Service Bulletin				
Revision Date 07-April-2016	Problem Code ECT00	Warranty ☒ Normal warranty	Pages 7	Author Bill Hughes Scott Repplinger
Document No.:	EC160407		Rev.:	0
Subject:	Replacing the Engage 15 Inch Console LCD Panel			
Time Required:	☐ 15 min ☐ 30 min ☐ 45 min ☒ 1 hr+			
Life Fitness proprietary and confidential information. For the use of the intended recipient only. The information and instructions in this bulletin are intended for use by skilled technicians. Warranty information is for reference only and is subject to change. Contact the local Life Fitness representative for more information.

This service bulletin provides detailed instructions to replace the Engage LCD panel, due to obsolescence, with a LCD panel that is NOT a direct replacement for the original LCD.

Figure 2 - Touch Screen Chassis

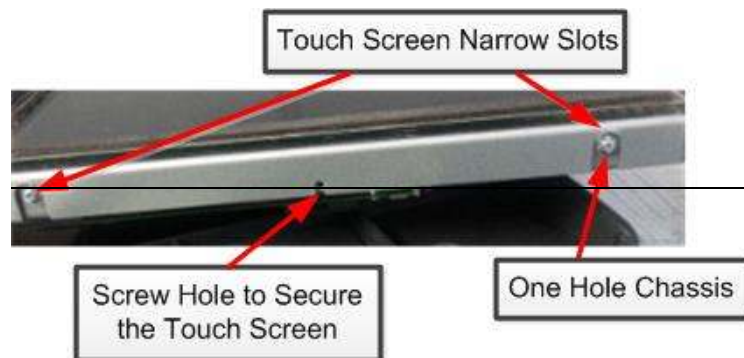
Inspect the edge of the chassis where the touch screen frame attaches to the chassis. See **Figure 2**. There will be access slots allowing access to the mounting holes and screws on this edge of the chassis. There are 2 chassis types:

- i. Single mounting hole/slot: This fits the original 15" LCD panel only;
- ii. Two mounting holes/slots: This fits both the original and new 15" LCD panels.

Figure 3- Touch Screen Frame

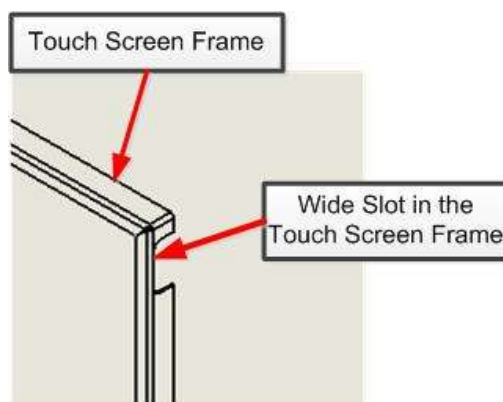
Inspect the corners of the touch screen frame. See *Figure 3*. There will be a wide or a narrow slot in the edge of this frame.

- i. The original touch screen frame has a narrow slot (~3/8" wide), corresponding to a single mounting hole in each corner of the frame. If the touch screen frame has narrow slots, the frame must be separated from the chassis to determine which chassis is in the product.
- ii. Newer touch screen frames have wide slots to accommodate a chassis with two LCD mounting holes. Some consoles were manufactured with the new two-hole chassis, along with the original LCD and narrow touch screen frames.

Figure 4- Key Connectors

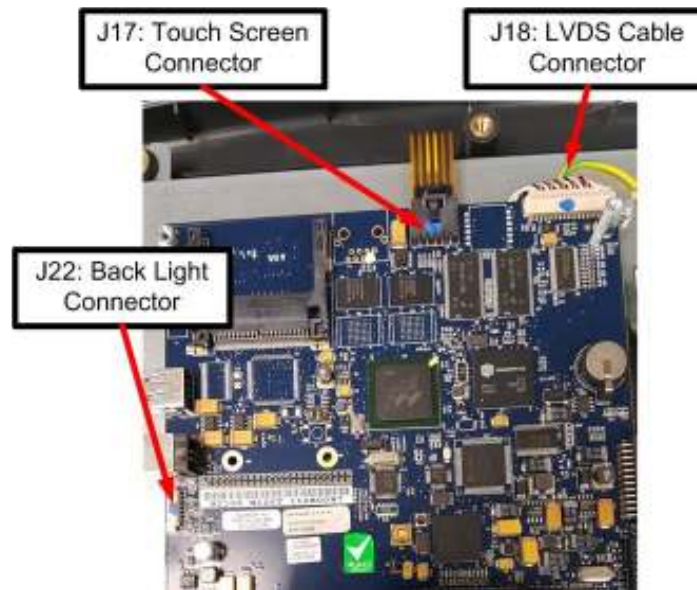
- 1) Remove the screws securing the console and set aside for later use.
- 2) Open the console and remove the screws securing the metal chassis to the front of the plastic. Set aside for later use.
- 3) Remove the screws identified at “Screw Hole to Secure Touchscreen” in Figure 2. Disconnect the touch screen from J17. Place the touch screen, screen up, in a secure location where it will not become damaged. Disconnect the LVDS cable from J18 and the grounding ring next to it. Discard this cable.

- 7) Install the new LVDS Cable (AK65-00061-0002) into location J18 and adjacent grounding location (per Figure 4).
RECOMMENDED: Loosen the screws shown in Figure 5 to make it easier to route the LVDS cable underneath the board and through the correct chassis cutout location to the front of the chassis.
- 8) Connect the new backlight cable (AK70-00105-0000) to J22 (per Figure 4).
RECOMMENDED: Loosen the screws shown in Figure 5 to make it easier to route the backlight cable underneath the board and through the correct chassis cutout location to the front of the chassis.

Figure 5- Proper location of boards.

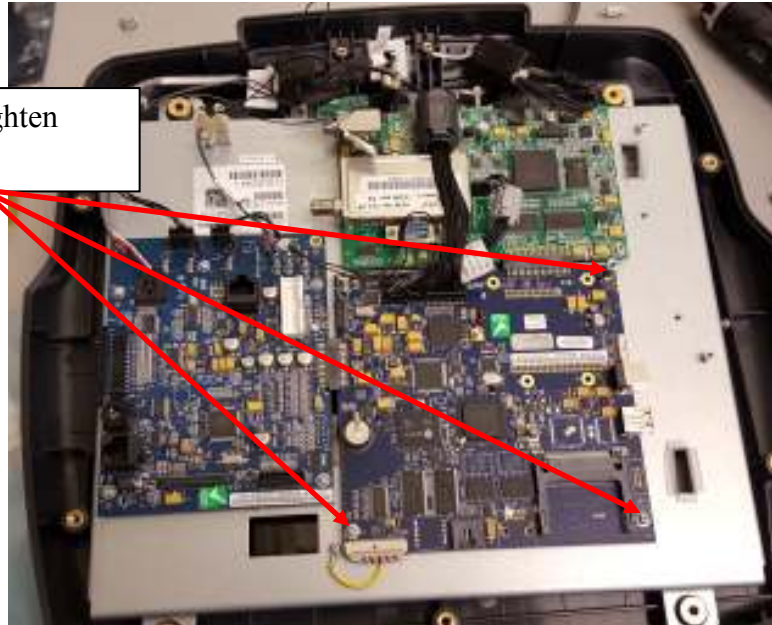
- 4) If populated, remove the inverter board along with the related wires and discard it along with all cables attached to the inverter board. Reference Figure 1 for image of inverter board.
- 5) Remove the two screws per side securing the LCD screen in place. Set aside the screws for later use. Remove the existing LCD screen and discard.
- 6) If the existing console chassis is the two holes per slot chassis, skip to step 7. If the console chassis is the one hole per slot chassis, all boards and components will need to be transferred to the newer two holes per slot chassis. It is recommended that each board be removed from the original chassis first so that wiring can be maintained. Install all the boards together in the same location on the new chassis.

Recommended: Do not tighten these screws at this point.

Figure 6 - LCD Backside View

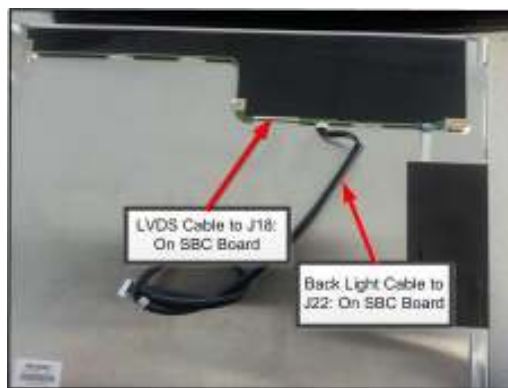
- 9) Bring the new LVDS cable and backlight cable through to the front of the chassis. Connect the cables to the rear of the LCD screen as shown in Figure 6.

RECOMMENDED: Be careful when working with the wires and connectors it is very easy to bend connector pins or pull wires from the connector housing, especially with the LVDS cable running between the SBC and the LCD.
